## NOTICE OF SWIMMING POOL NON-COMPLIANCE

**Premises to which this notice relates:** 11 Holland Crescent Frenchs Forest.

**Pool Installation Description:** In-ground concrete swimming pool

## 2. Defect/non-compliance identified

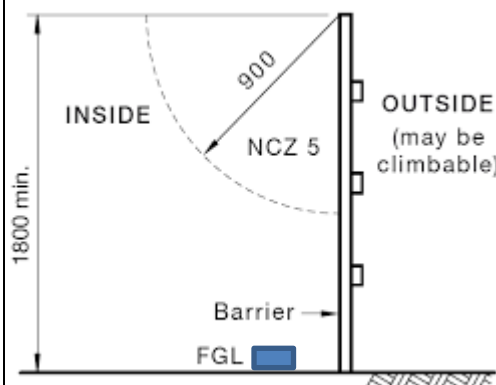
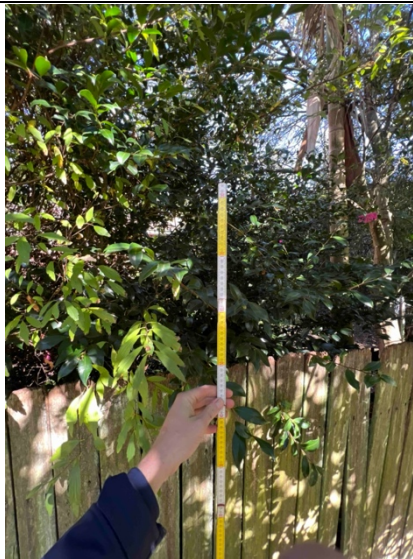
The effective height of the boundary fences was not 1800 mm or more. The height of the fences was measured from the top of the fence to the ground level on the pool side of the fence.

Raise the boundary fences so they are 1800 mm or more in height (measured on the pool side of the fence). The height of a boundary fence is measured from the top of the fence to the ground level on the pool side of the fence. Where there is an object such as pavers, raised garden bed or decking etc within 500 mm of the boundary fence, the 1800 mm in height is measured to that object and not the ground. Alternatively, any ground or surface object on the pool side of the fence could be lowered or removed (500 mm or more away from the fence) so that the 1800 mm effective height of the fence is achieved. If the fence height is increased, the required 900 mm NCZ 5 is required to be measured from the top of the fence so that any fence extension construction provided on top of the existing fence must not have footholds greater than 10 mm wide within 900 mm of the top of the extended fence. The new 1800mm boundary fence height must run for 900mm past each intersection with the internal barrier.

**3. Defect/non-compliance identified**

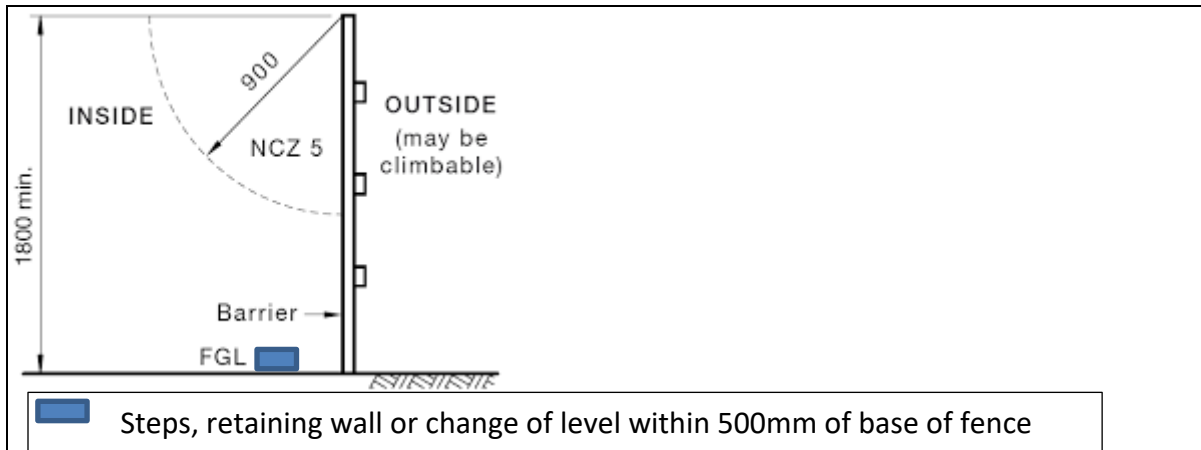
A rail was located on the inside of the boundary fence that could be used as a foothold for children to climb down into the pool enclosure.

Shield the rail from within the 900 mm Non-Climb Zone (NCZ 5). The NCZ 5 is a 900 mm arc measured from the top of the fence and is quarter-circle in shape. If the rails are to be shielded, the minimum angle or splay of the shielding is 60 degrees. There is specifically designed 60-degree sections of timber that can be attached to the top surface of the rail.

#### 4. Defect/non-compliance identified

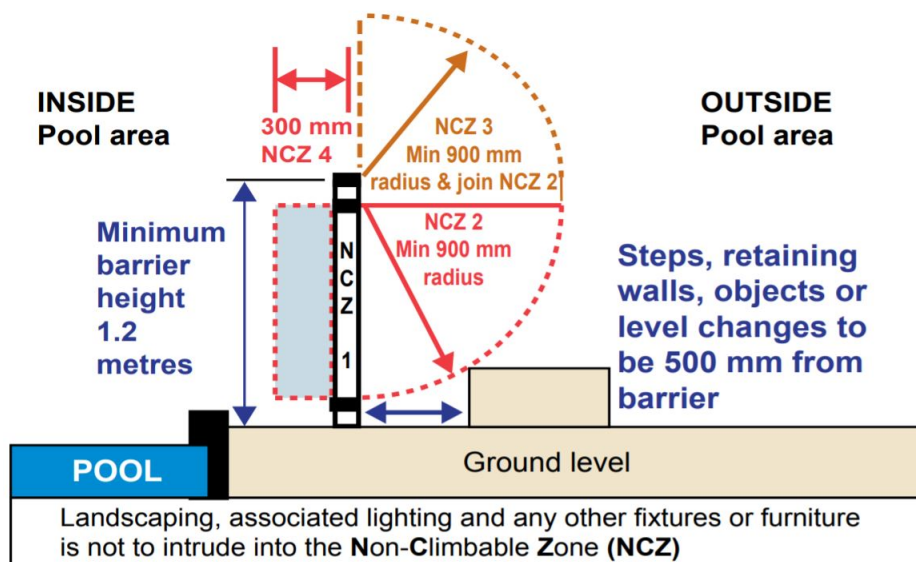
There were gaps in the boundary fence greater than 100 mm. Gaps greater than 100 mm are not permitted in or under the pool fence. Sections of the boundary fence were missing palings. There was also a section of the boundary fence that was leaning over and had broken away from the neighbouring section of fence, creating a larger gap.

Reduce all gaps to less than 100 mm using permanent and structurally adequate construction. Repair or replace the sections of damaged fence so the structural integrity of the fence is maintained.

6. **Defect/non-compliance identified**

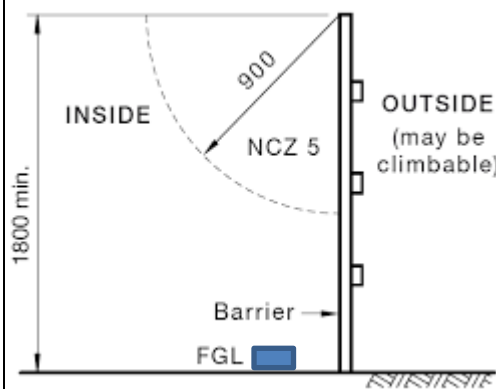
Vegetation was located on the inside of the boundary fence that could be used as a foothold for children to climb down into the pool enclosure.

Remove or prune the vegetation so that no climbable branches or fork sections are within the 900 mm NCZ 5.
